Staff Report

Re: PLNPCM2020-00641 – 9th East Mixed Use and Multifamily

Design Review

PROPERTY ADDRESSES: 402 South 900 East and 410 South 900 East

CONSULTANT:

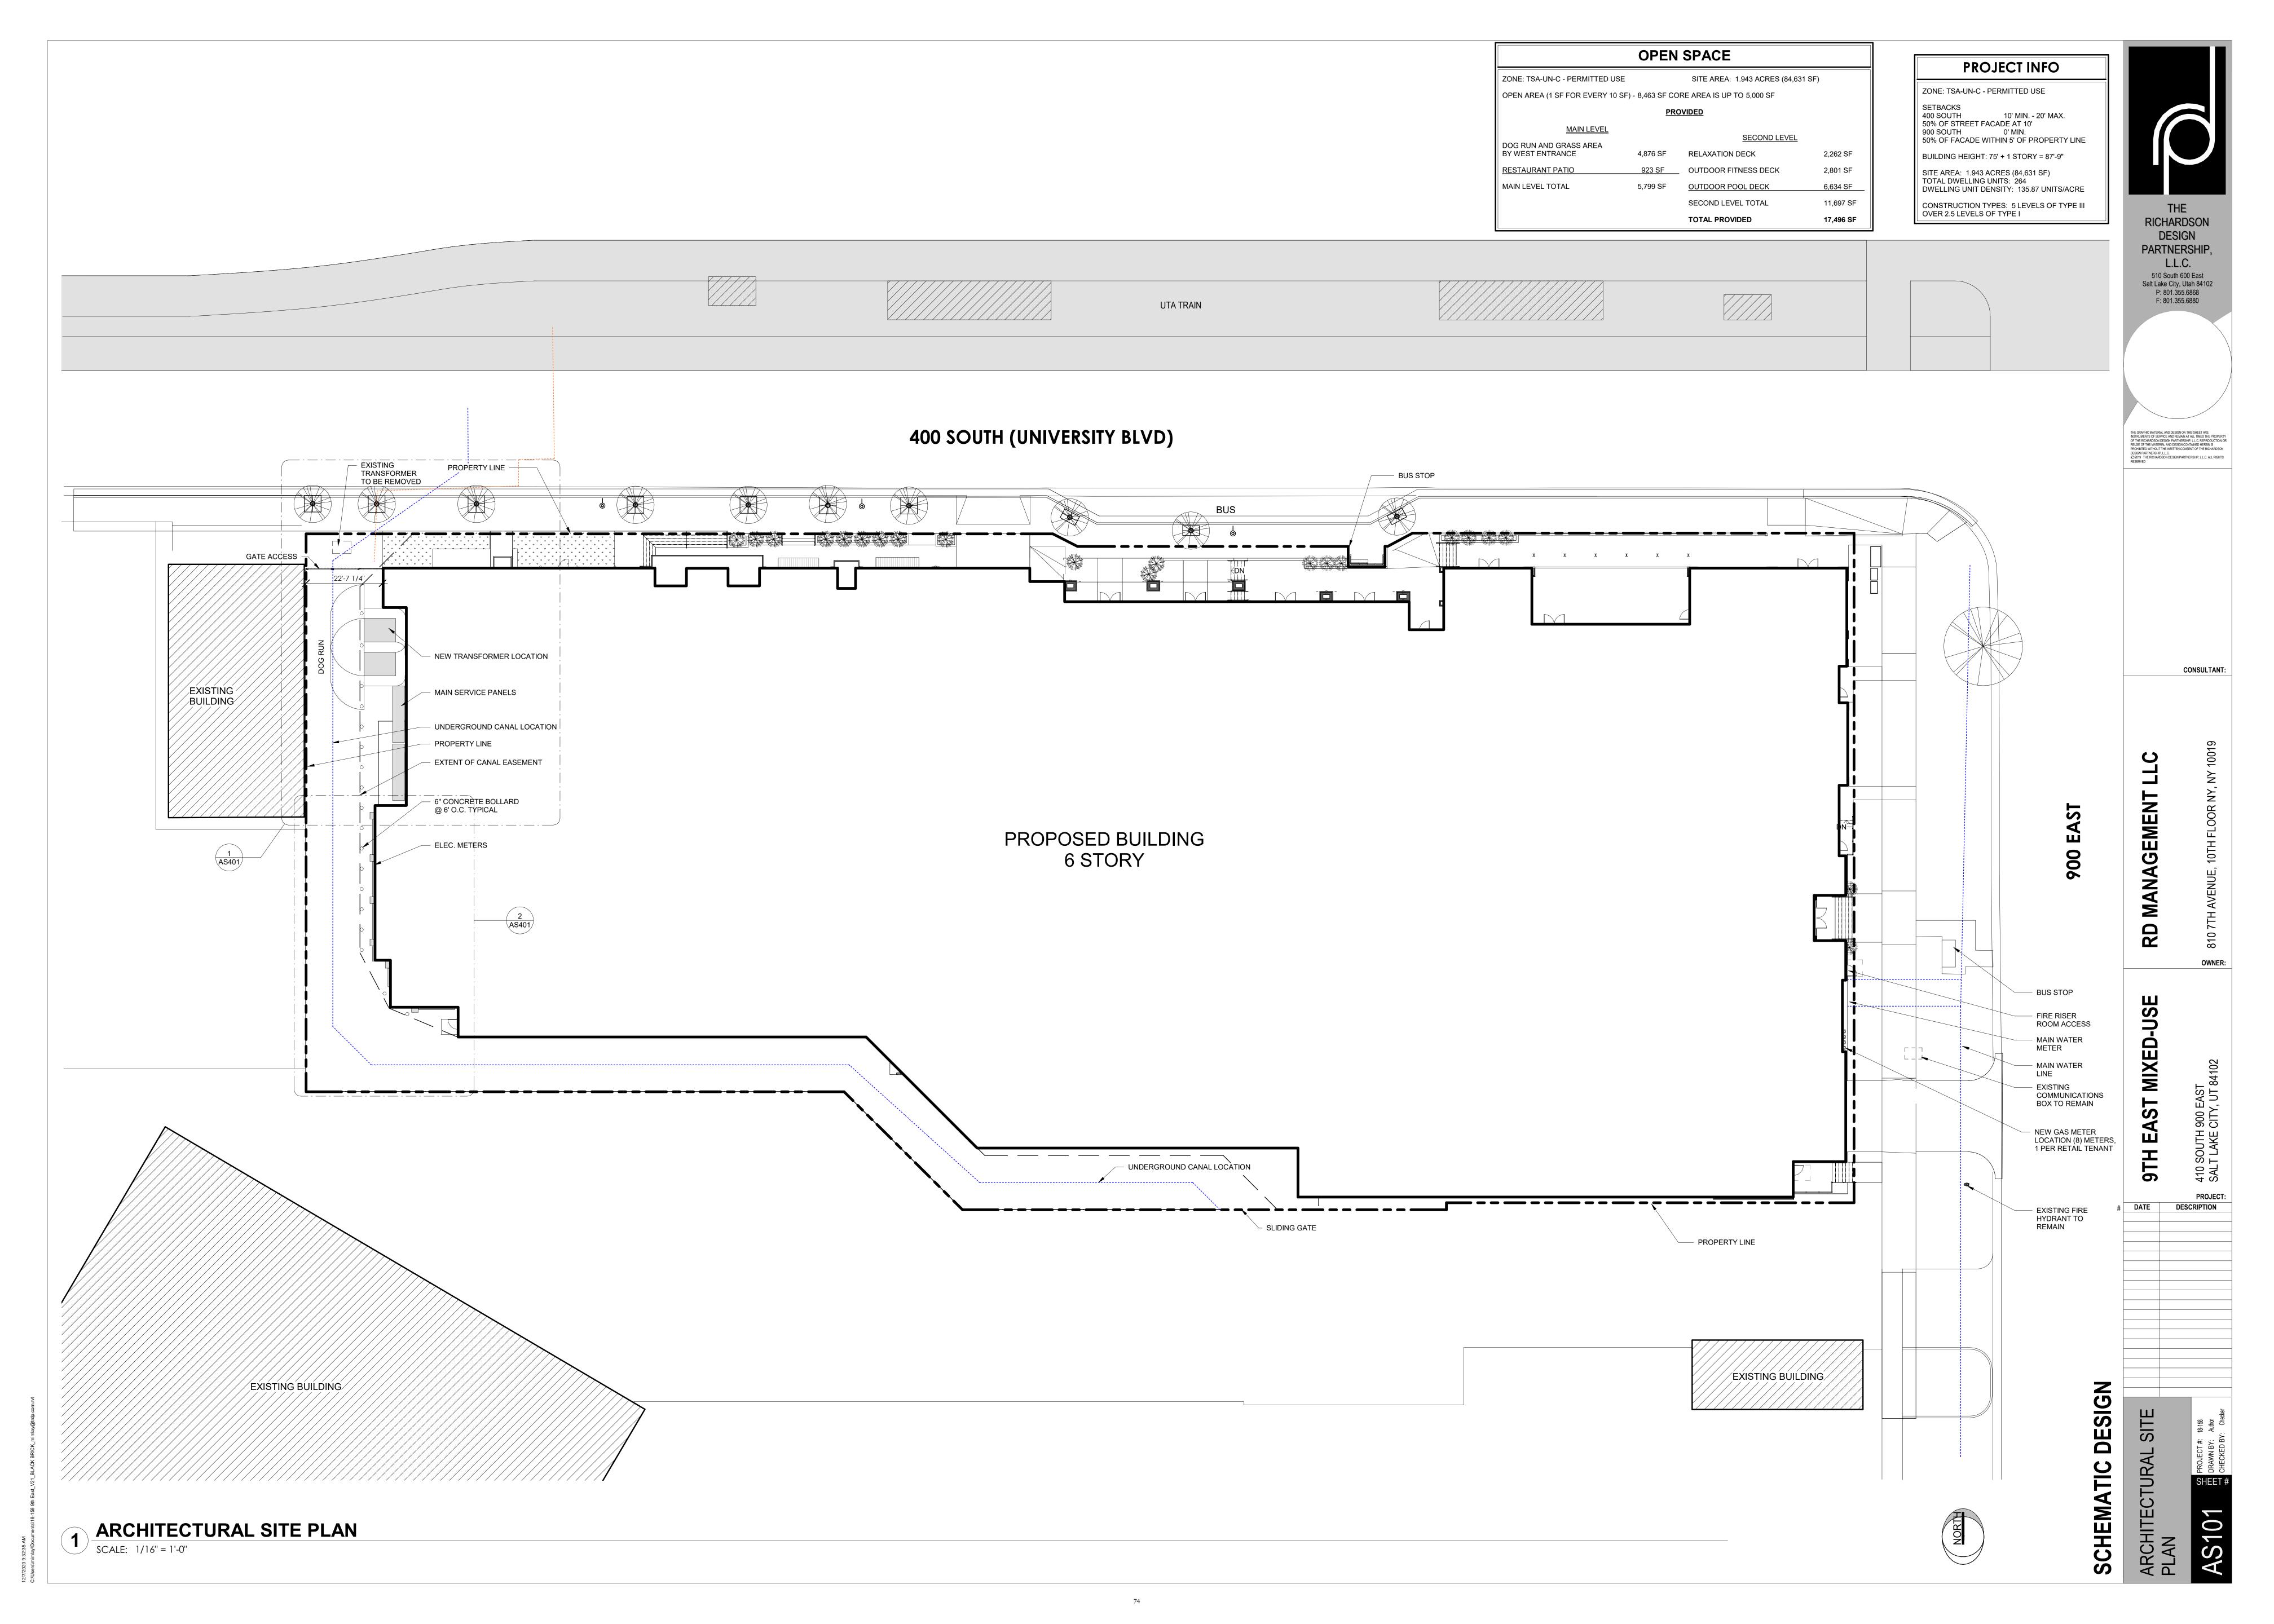
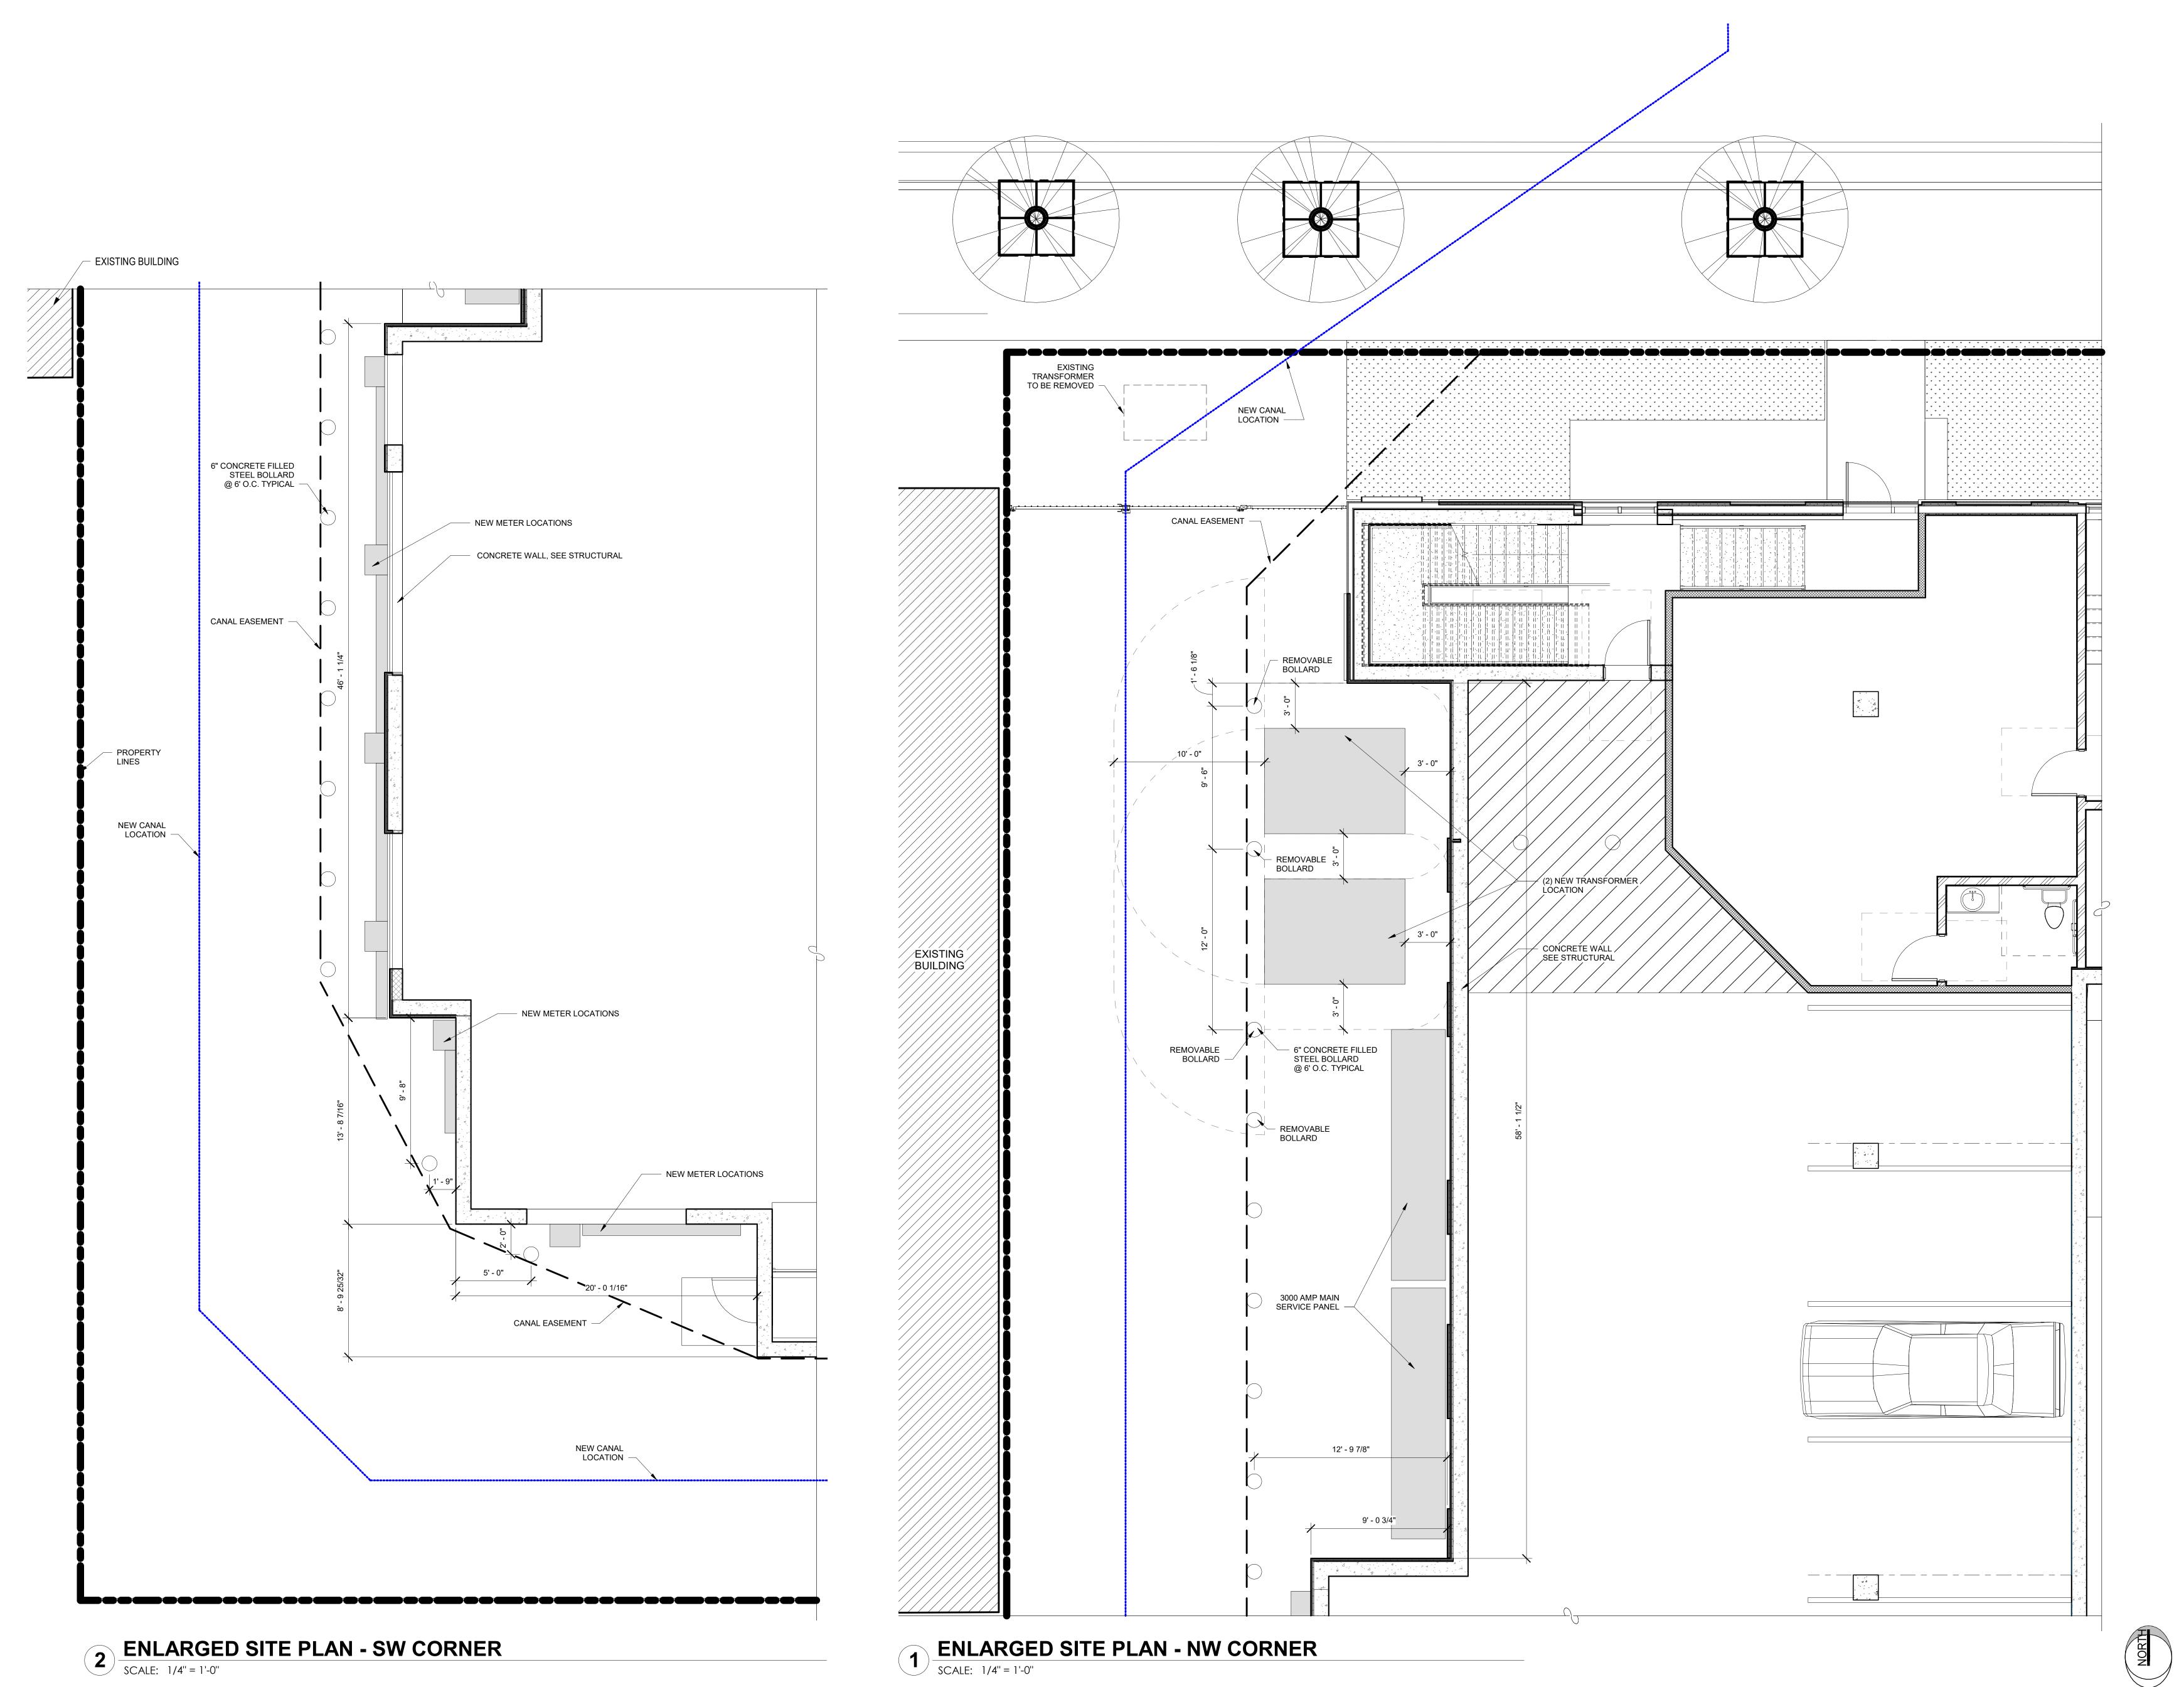
• 21A.26.078.F.2.a limits the use of EIFS and stucco to 10% of the upper level street facing façades. Please provide the percentage of EIFS and stucco for each façade.

North Elevation: Level 2 & up has a total of 17,304.52 sf of material not including windows or doors. The durable material is 65% (11,316.19 sf), brick and concrete. There is 4% (626.90 sf) of break metal material. There is 31% (5,361.43 sf) of a synthetic acrylic coating over rigid insulation that mimics a metal panel. We have provided a brochure from the manufacturer to further clarify the appearance of the material.

East Elevation: Level 2 & up has a total of 6387.49 sf of material not including windows or doors. The durable material is 62% (3936.94 sf), brick and concrete. There is 1% (45.41 sf) of break metal material. There is 37% (2405.14 sf) of a synthetic acrylic coating over rigid insulation that mimics a metal panel. We have provided a brochure from the manufacturer to further clarify the appearance of the material.

Response: Updated material calculations have been provided on the revised elevations.
